PLAN
"ARTER PROPERTY" PLAT # 3732
SECTION DISTRICT
HARD COUNTY, MD
SCALE - 1" = 30'

SITE PLAN
 LOT 2 "WATER PROPERTY" PLOT #3132
 4TH ELECTION DISTRICT
 HOWARD COUNTY, MD.
 9/9/20 SCALE: 1"=30'

SITE PLAN
 LOT 2 "AKTER PROPERTY" PLAT #3732
 4TH ELECTION DISTRICT
 HOWARD COUNTY, MD.
 9/9/80 SCALE: 1"=30'

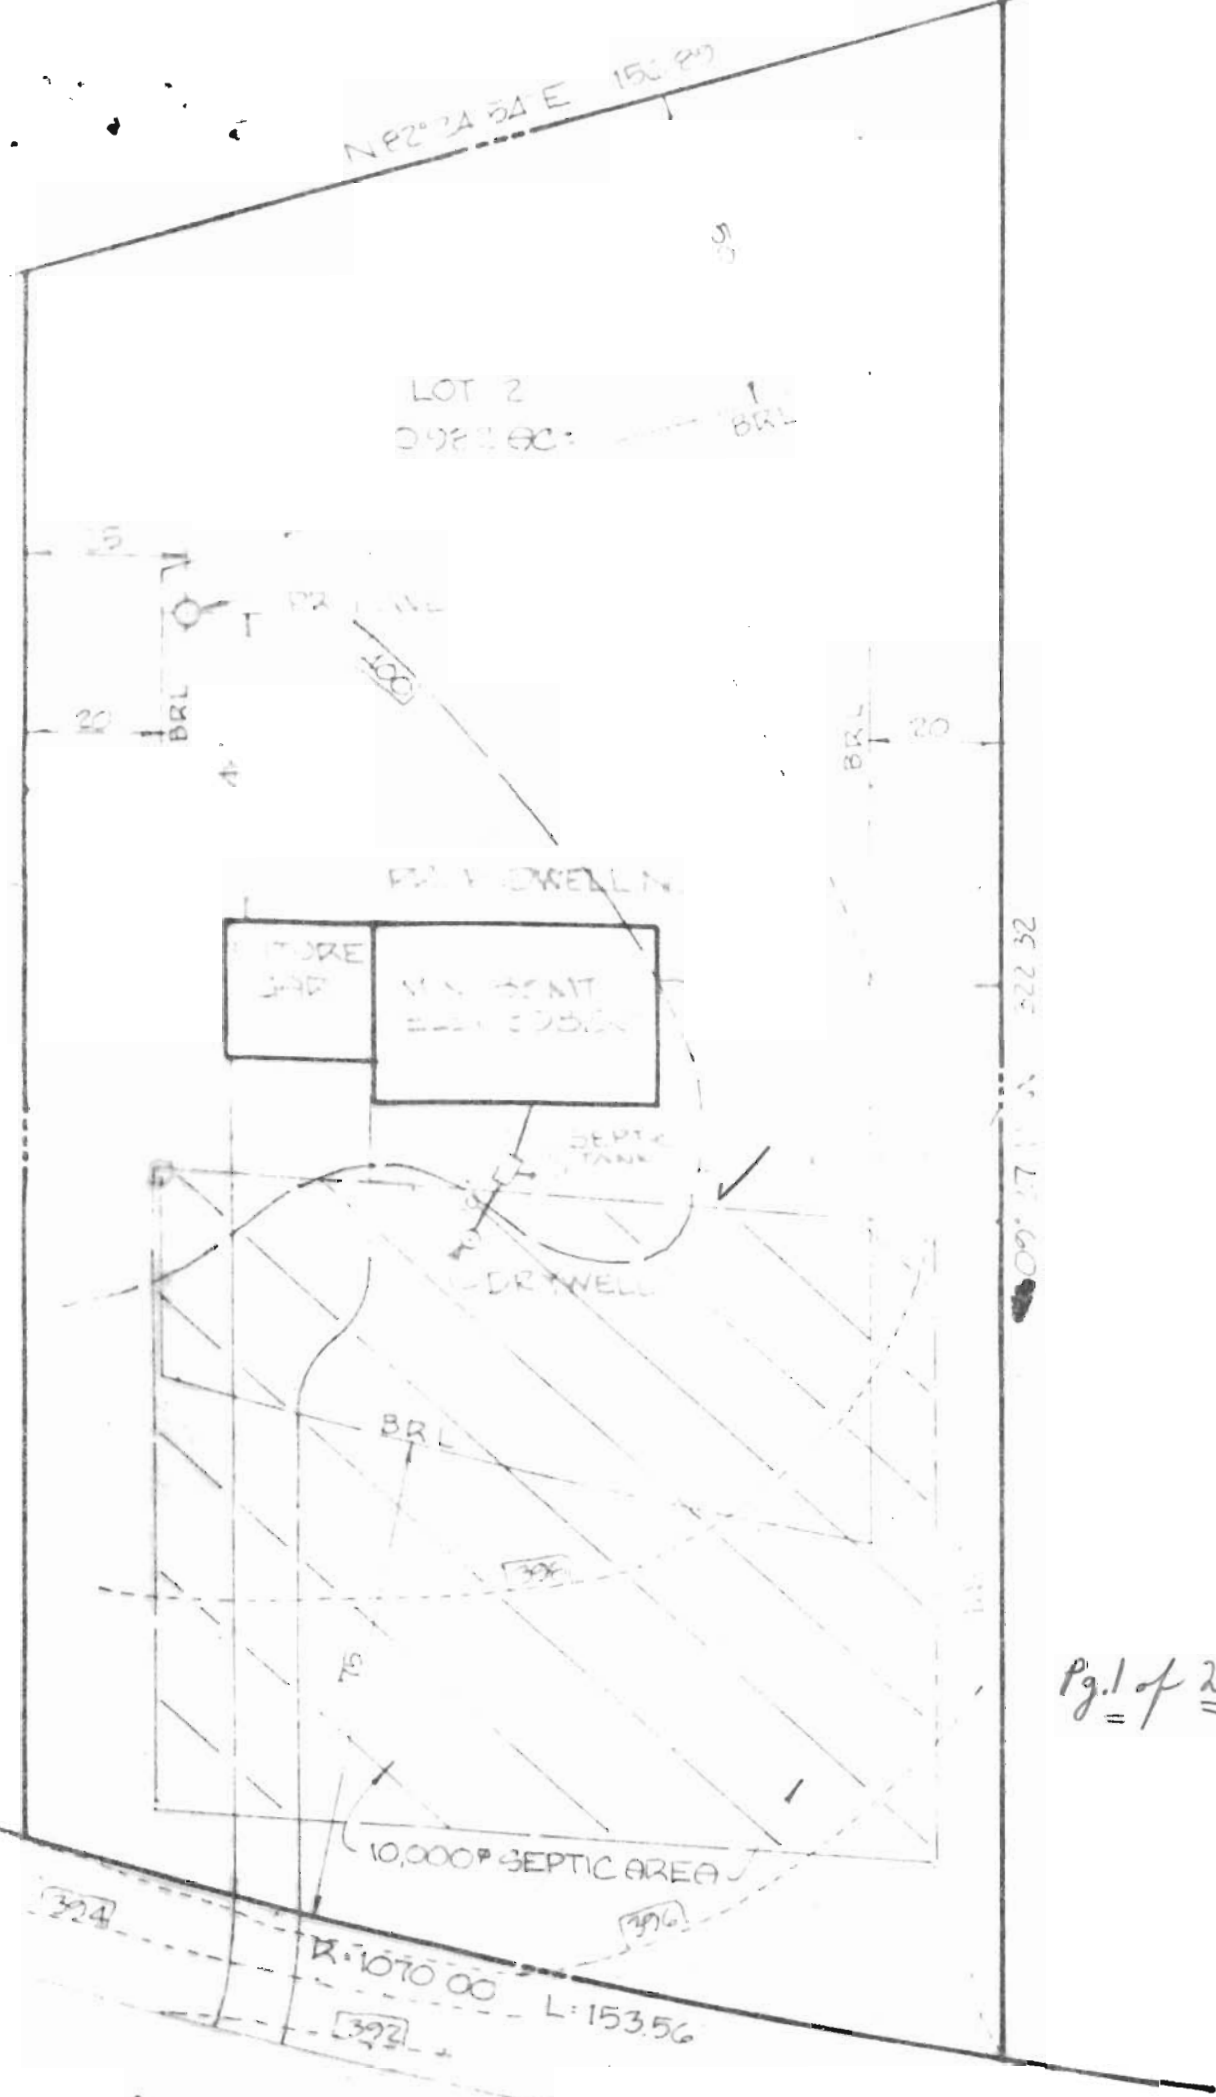
To change
D.W. location
and
3.5' below
grade

See Revised 9/16/80
C.B.D.

(3) { Recommend scale }
be shown
also!!

P.M. (1) Need certifying
statement

(2) Need to recompiled
elevations from
dry well to house

{ Hold for revised
plat C.B.D.

9/16/80 Revised ok. ✓
C.B.C.

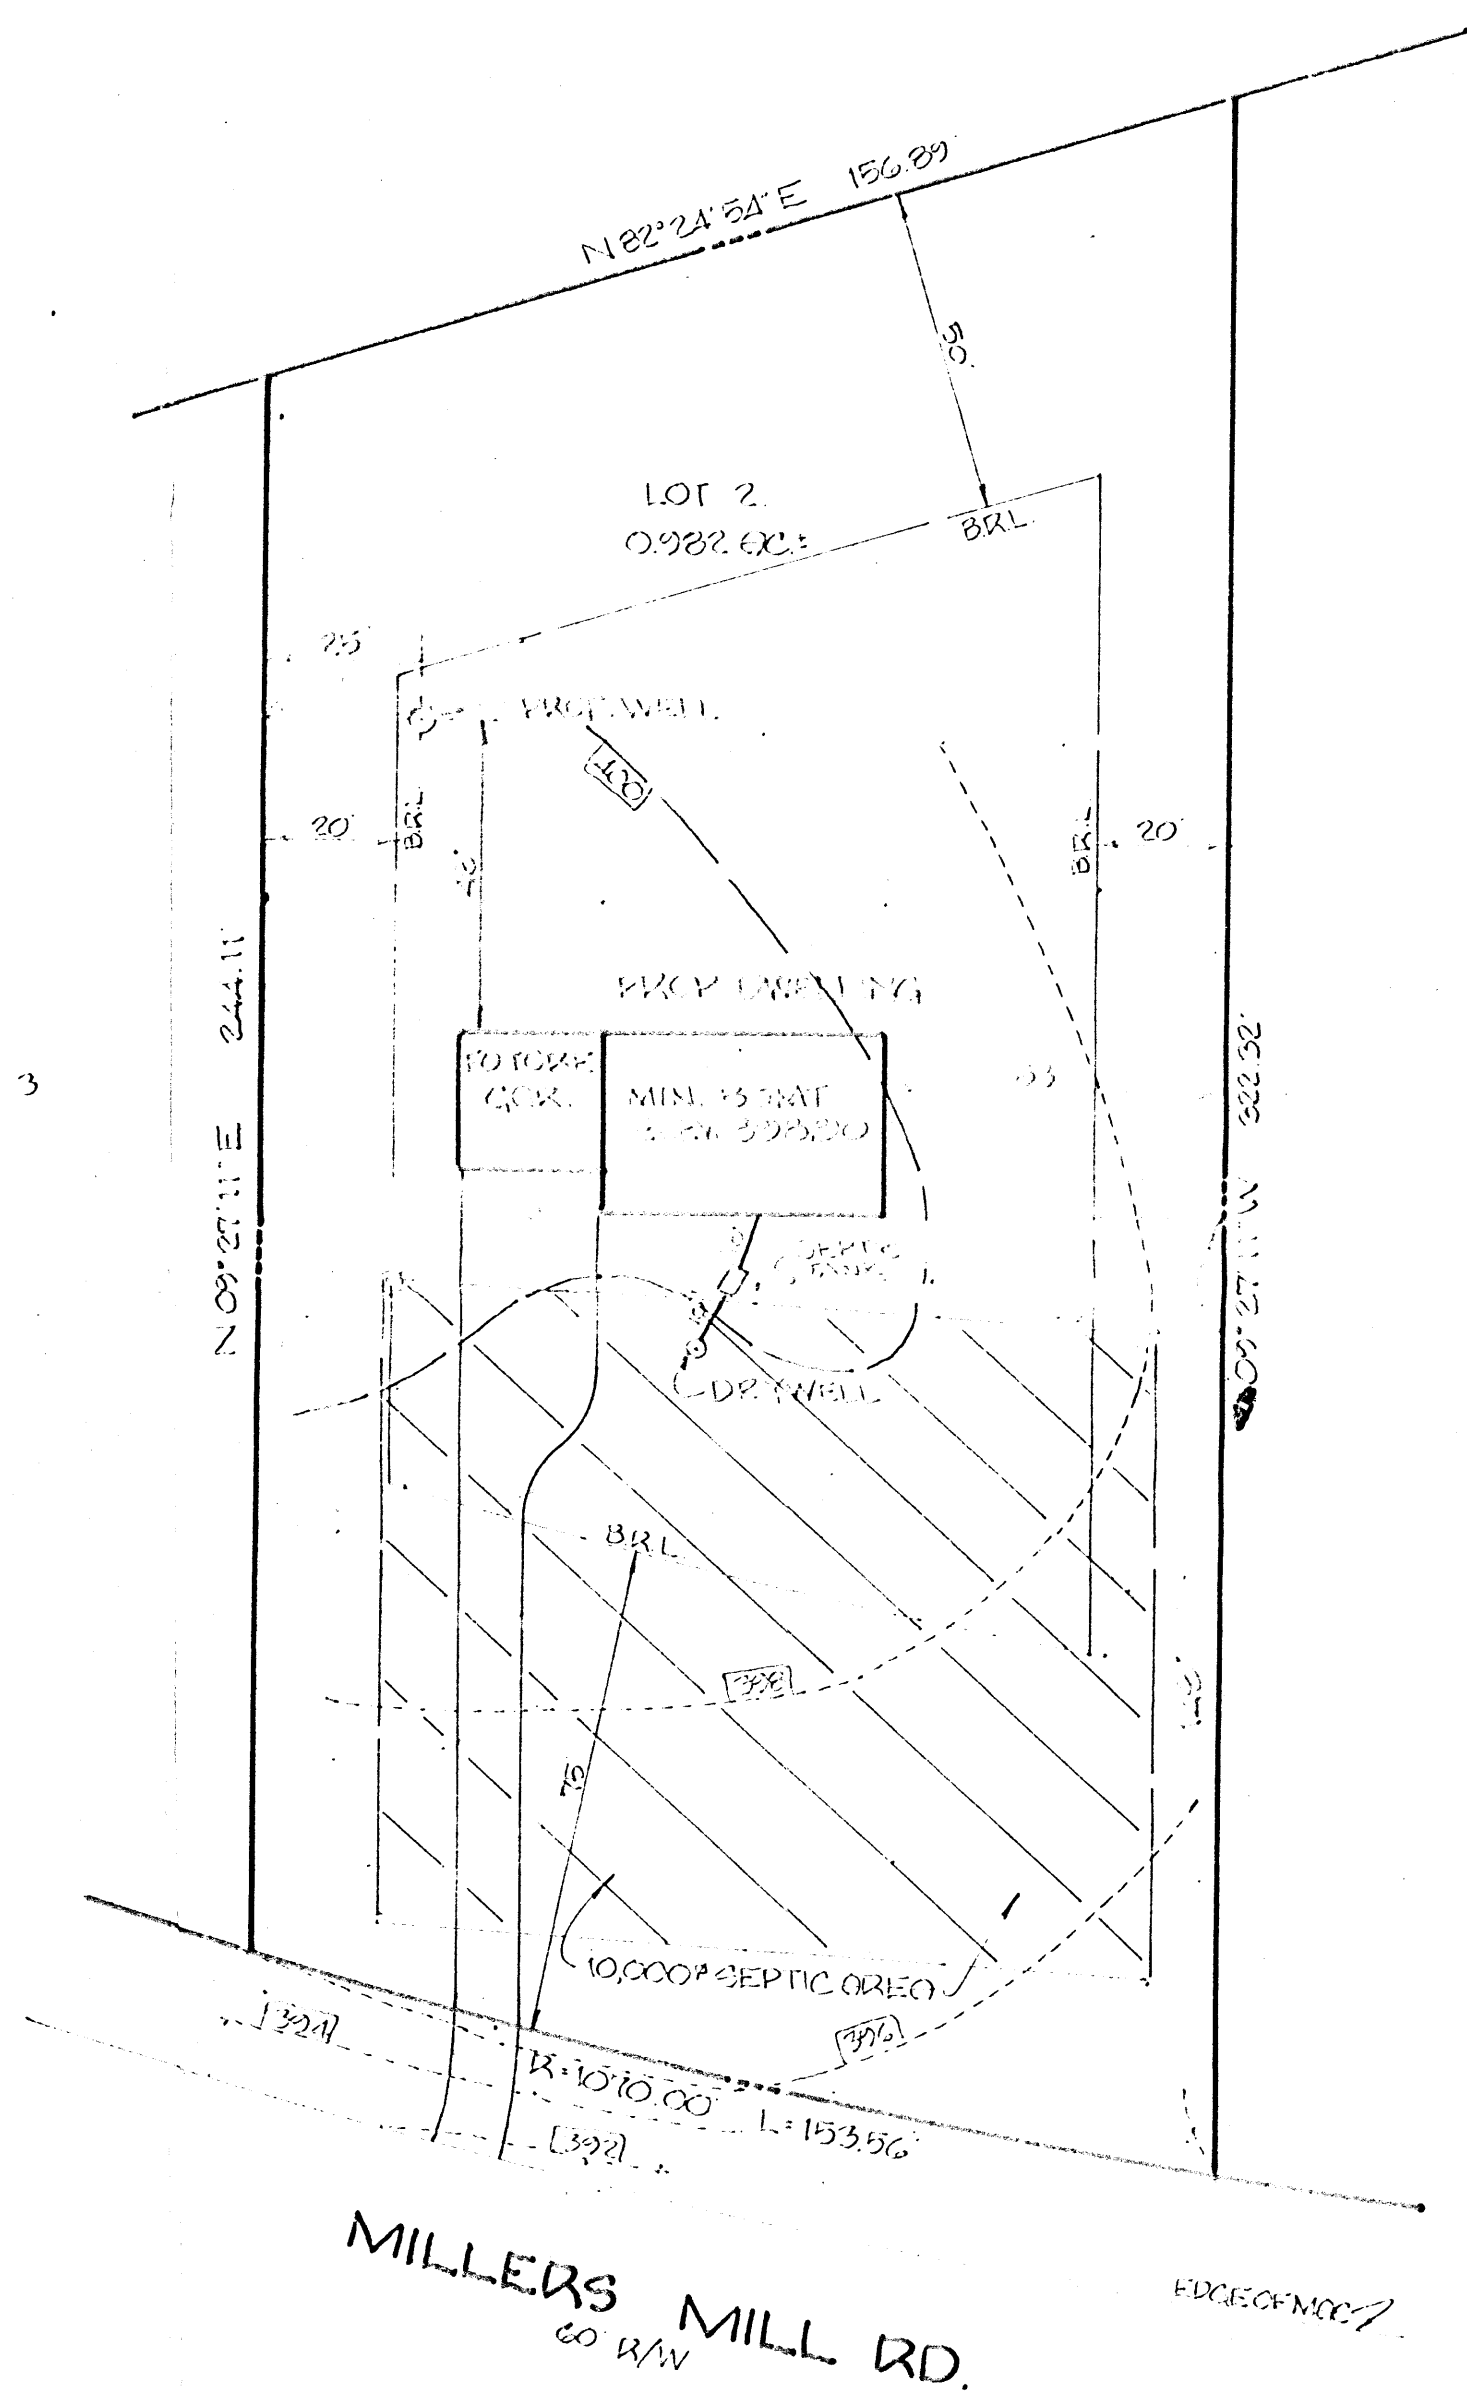
NO ACCEPTABLE 7/15/80
 NO DROP

VOID
 SEE REVISED
 7/15/80

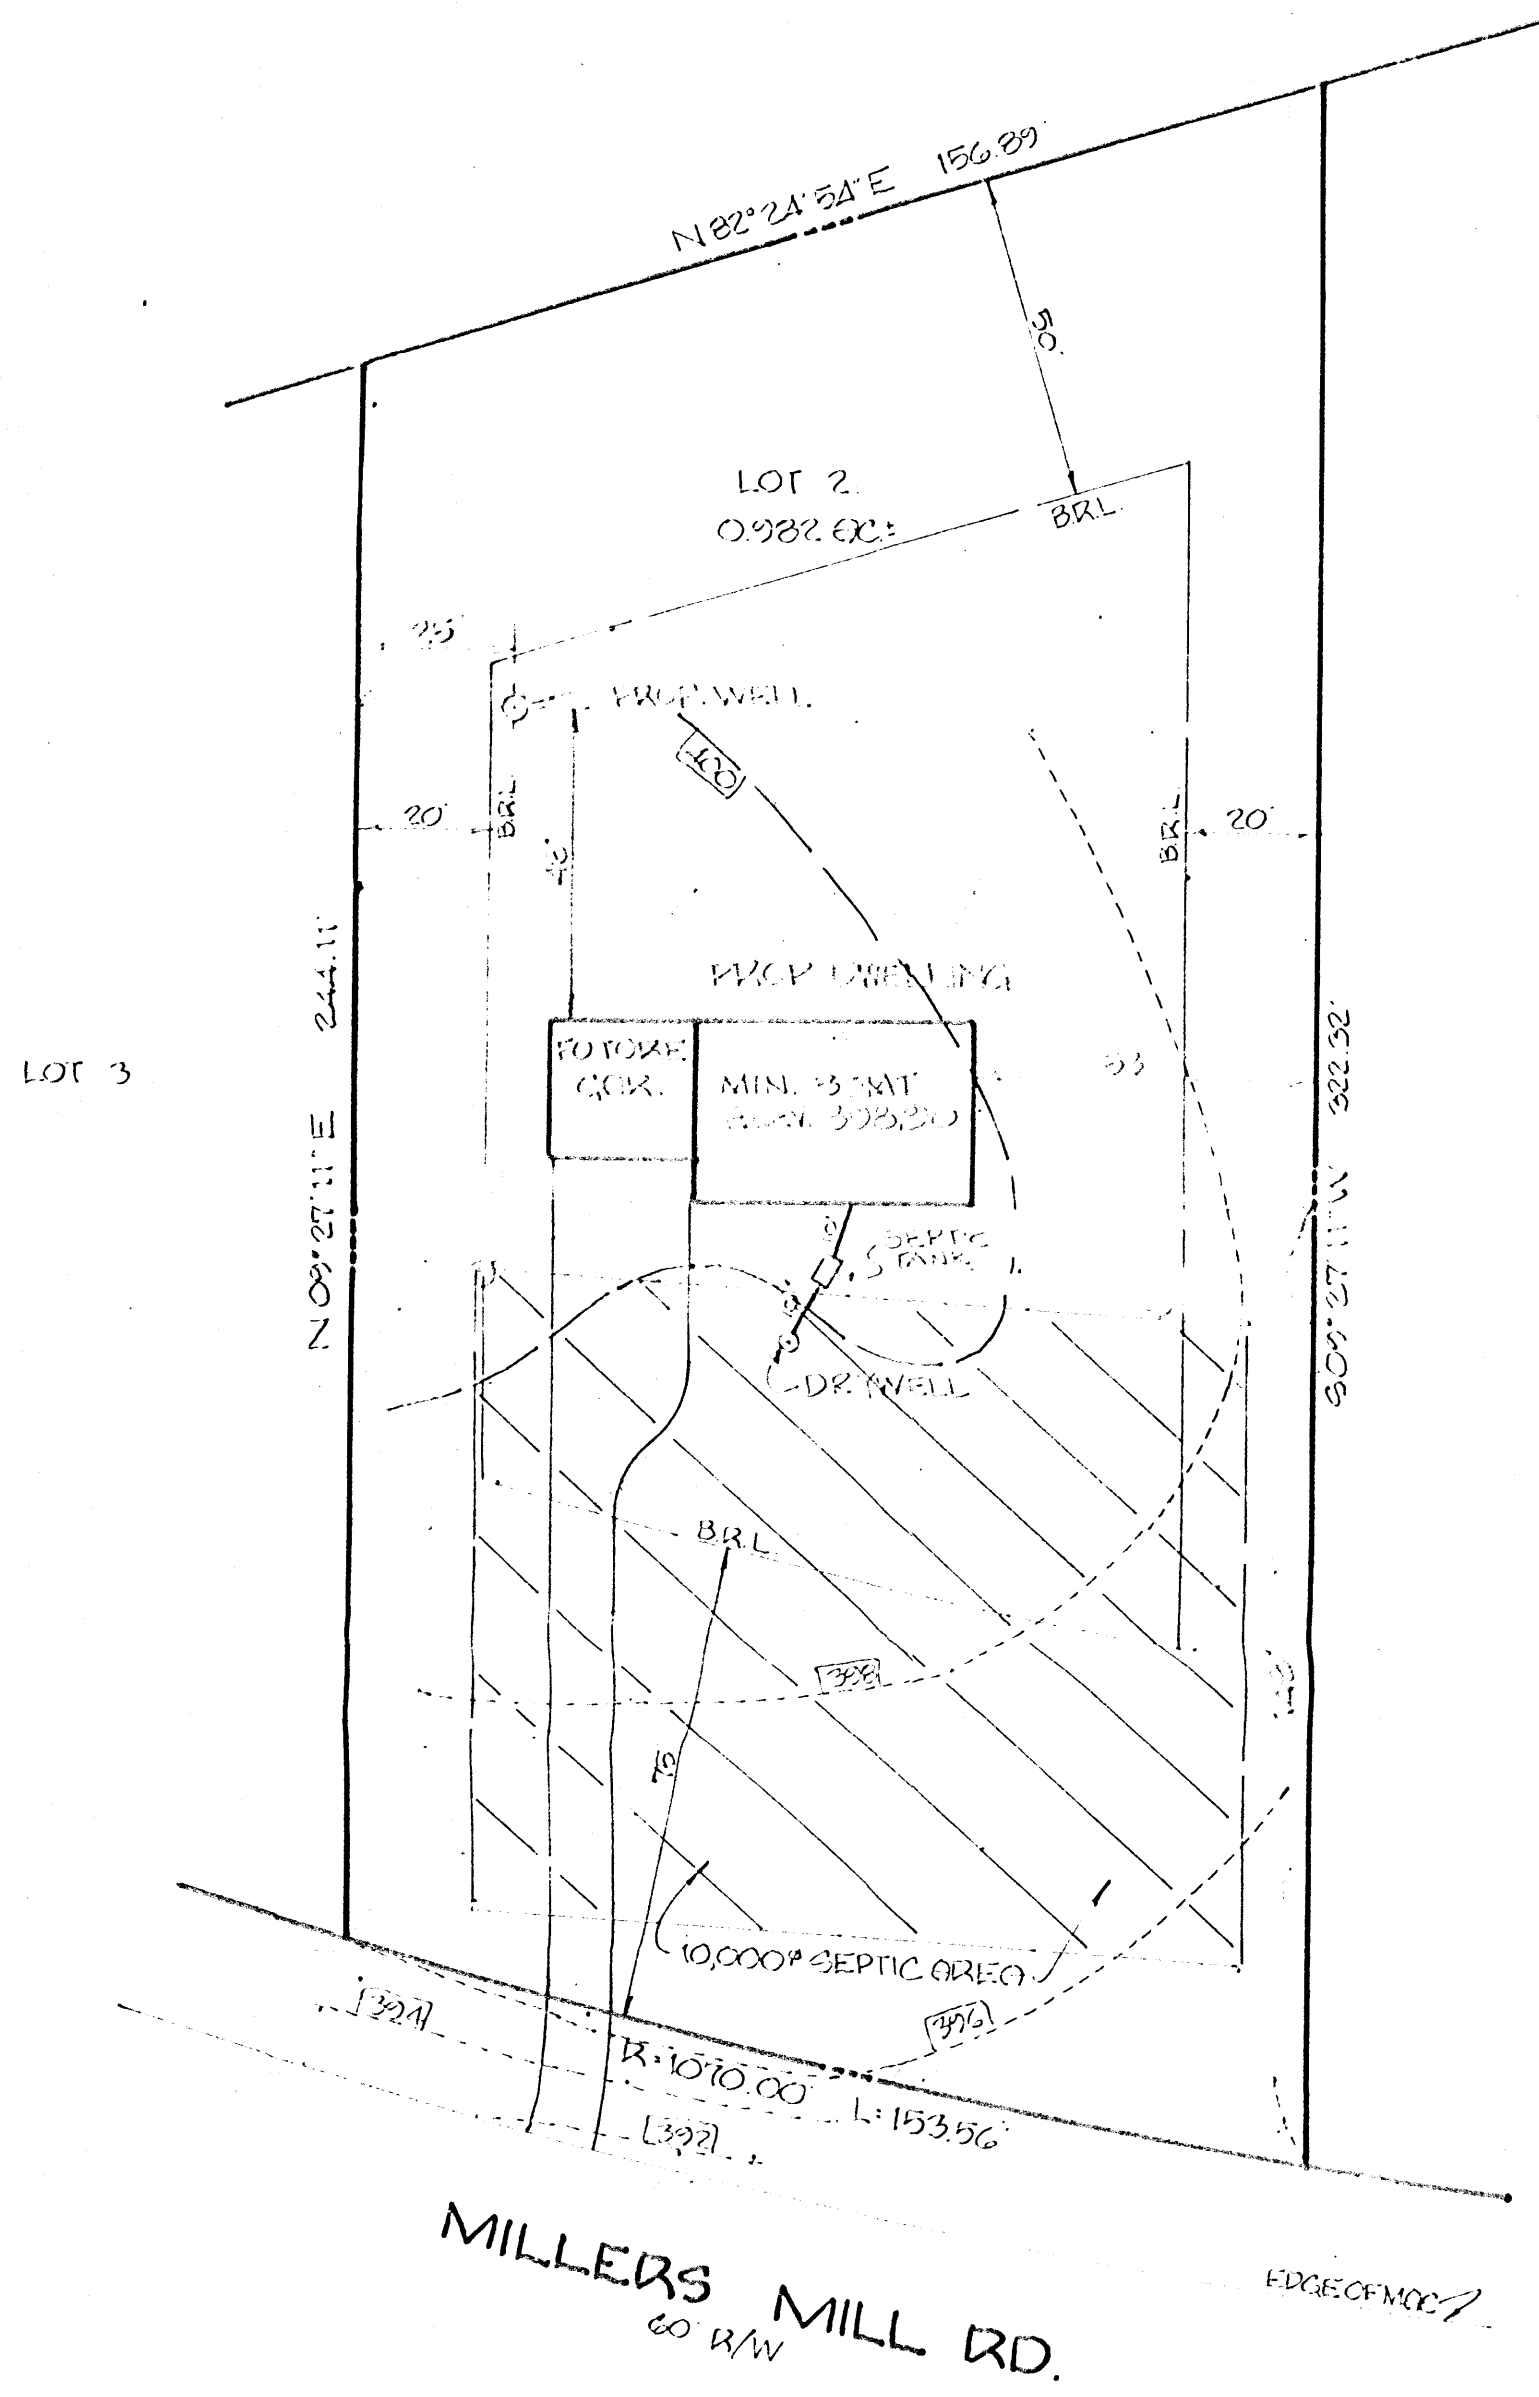
VOID
 SEE
 REVISED
 9/16/80
 E.B.A.
